Warranty Inspection Report

Project Ledyard School - Gales Ferry.		This insper	This inspection was performed to determine if any visual deficiencies exist. Work not yet complete or covered that cannot be inspected for compliance is the responsibility of the installing contractor.					
Project No. G-39041 Inspection			For insurance purposes, a copy of this report is being forwarded to the general contractor and					
Inspected by Michael Boland			architect for the project.					
Inst	pection Date & Time Nov 13, 2024 11:00:00	AM STATUS	STATUS UPON COMPLETION OF THIS INSPECTION:					
	aller The Imperial Company	C NO	NO VISIBLE DEFICIENCIES: Report submitted for the record.					
Inst	aller Office Contact Bruce Raulukaitis	e const 7						
Inst	aller Field Contact Bruce Raulukaitis		C MINOR DEFICIENCIES NOTED: See report for details.					
Oth Brue	er attendees at inspection Company ce The Imperial Co.			Car report for d	leteile

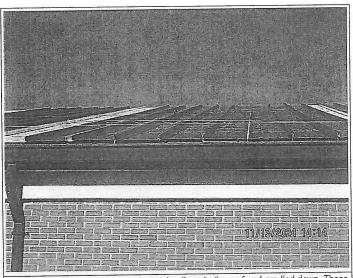
Staged panels have one screw securing them to the roof and are tied down. These panels are not considered installed. Staged panels should be installed as soon as possible as this may cause an unsafe condition.

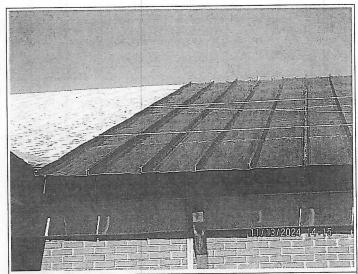
3. Staged panels have one screw securing them to the roof and are tied down. These panels are not considered installed. Staged panels should be installed as soon as possible as this may cause an unsafe condition. Back of main building between dormers. Panel ribs are not formed correctly and will be replaced by Garland.

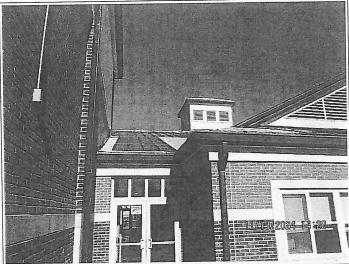
4. Staged panels have one screw securing them to the roof and are tied down. These panels are not considered installed. Staged panels should be installed as soon as possible as this may cause an unsafe condition. Back of main building between dormers. Panel ribs are not formed correctly and will be replaced by Garland.

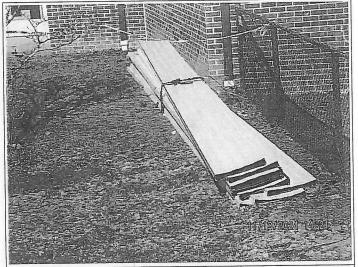
5. Staged panels have one screw securing them to the roof and are tied down. These panels are not considered installed. Staged panels should be installed as soon as possible as this may cause an unsafe condition.

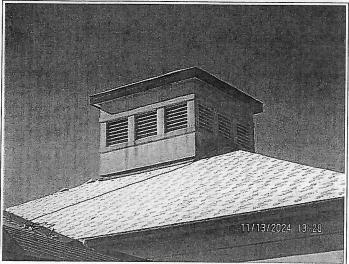
Improperly stored panels that have damage will be replaced at the installer's expense.

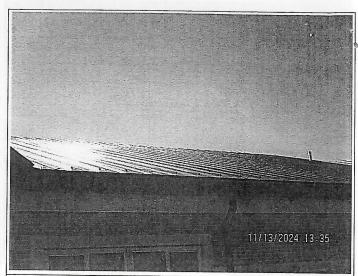
7. Front cupola. Headwall flashing will be tucked under existing flashing. Lined with a continuous bead of sealant and riveted with stainless steel, closed end rivets at 4" oc.. For the front section, a 16 ga plate will be secured to the existing framing. The sidewall/jamb flashing will be set in a continuous bead of sealant and secured to the 16 ga. plate. A new detail will be submitted separately.

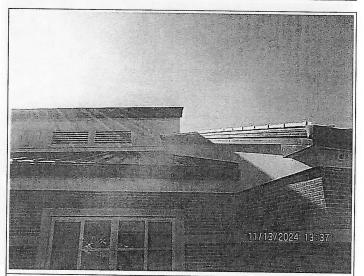
9. Front octagonal roof. Panel ribs do not meet at the hip but are centered as with all similar roof sections. We will wait for direction from Wayne as to whether he wants the ribs to match or the panels to be centered. If the ribs must match at the hip, Garland will send replacement panel. Imperial will supply the labor as this condition should have been discussed previously.

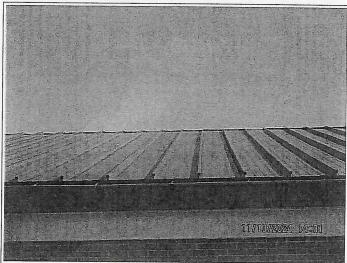
10. Same location. The sidewall/jamb will be sealed using a hip assembly. The new flashing will be tucked under the existing, set in a continuous bead of sealant and riveted with stainless steel, closed end rivets at 4" oc..

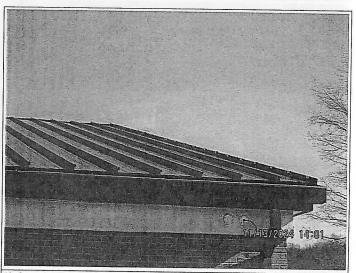
11. Rear wing at playground. Panels must be removed. A chalk line struck and panel clips centered on the chalk line. The panels must be clamped at each clip to remove the existing camber.

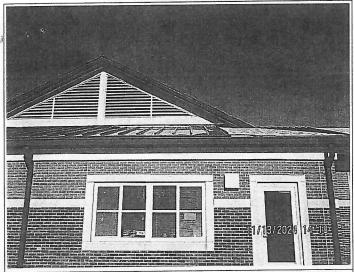
12. Same location. Gable clips must be installed at 17" in the 8' high pressure zone in the upper right corner. The remain gable clips are to be spaced at 20". Refer to the approved shop drawings.

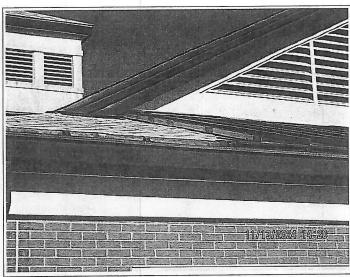
13. Dormer on back of main building. Panels are pan ended in compliance with shop drawings. Headwall flashing will be tucked under existing flashing, lined with a continuous bead of sealant and riveted with stainless steel, closed end rivets at 4" oc..

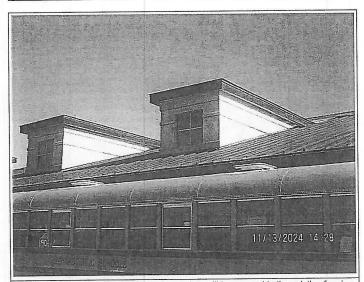
15. Walkway canopy substrate canopy is entirely covered with underlayment in compliance with shop drawings. It was agreed to drive a 1.5" screw through the deck to ensure it will not penetrate the finished underside. If the 1.5" screw does not penetrate the finished underside, 1.5" screws will be used to secure all gable clips in this area only.

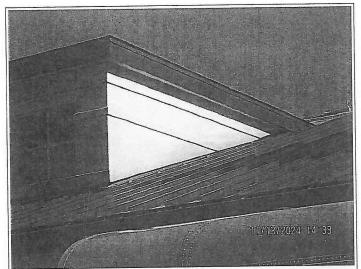
16. Bus loading zone, right dormer. A 16 ga plate will be secured to the existing framing. The sidewall/jamb flashing will be set in a continuous bead of sealant and secured to the 16 ga. plate. A new detail will be submitted separately.

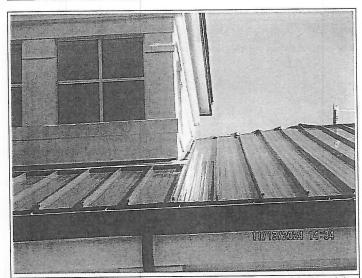
17. Bus loading zone, left dormer. A 16 ga plate will be secured to the existing framing. The sidewall/jamb flashing will be set in a continuous bead of sealant and secured to the 16 ga. plate. The Imperial Company will be responsible for removing EIFS to accommodate the new plate and flashing. A new detail will be submitted separately.

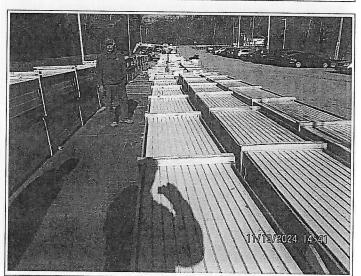
22. Panel crates should be shimmed so they are not resting on the end packing. Panels crates should be kept straight as not to introduce a camber or damage the panels.

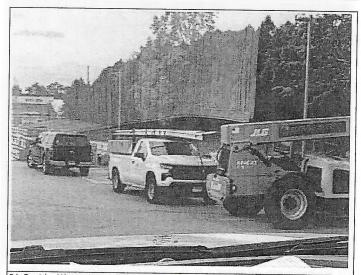
23. Sent by Wayne Donaldson. All panel crates must be moved using a spreader bar and straps wrapped at the crate 2x4 packaging. All damaged panels by mishandling will be replaced by the Imperial Co..

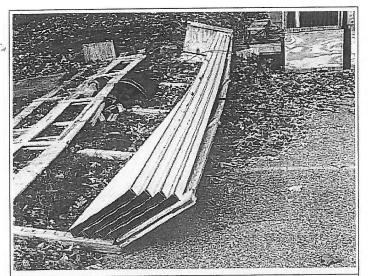
24. Sent by Wayne Donaldson. All panel crates must be moved using a spreader bar and straps wrapped at the crate 2x4 packaging. All damaged panels by mishandling will be replaced by the Imperial Co..

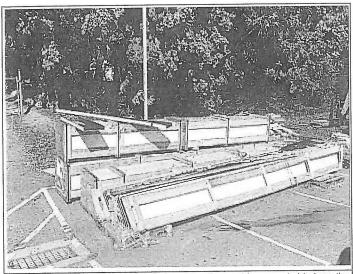
26. Sent by Wayne Donaldson. Scrap panels to be used in small cut conditions must be stacked and secured to maintain panel and rib shape.

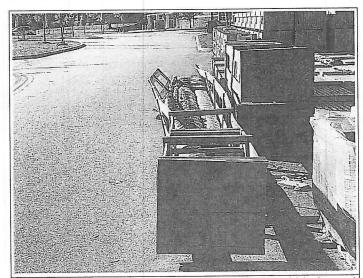
27. Sent by Wayne Donaldson. Panels in open crates must be supported to keep the integrity of the shape of the panel and ribs. All damaged panels by mishandling will be replaced by the Imperial Co..

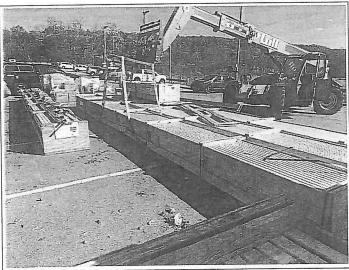
28. Sent by Wayne Donaldson. All materials must be protected to maintain shape and eliminate the possibility of damage.

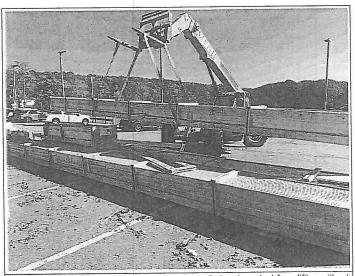
29. Sent by Wayne Donaldson. All panel crates must be moved using a spreader bar and straps wrapped at the crate 2x4 packaging. All damaged panels by mishandling will be replaced by the Imperial Co..

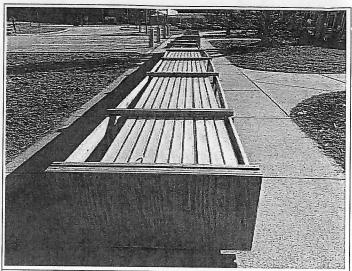
31. Sent by Wayne Donaldson. All panel crates must be moved using a spreader bar and straps wrapped at the crate 2x4 packaging. All damaged panels by mishandling will be replaced by the Imperial Co..
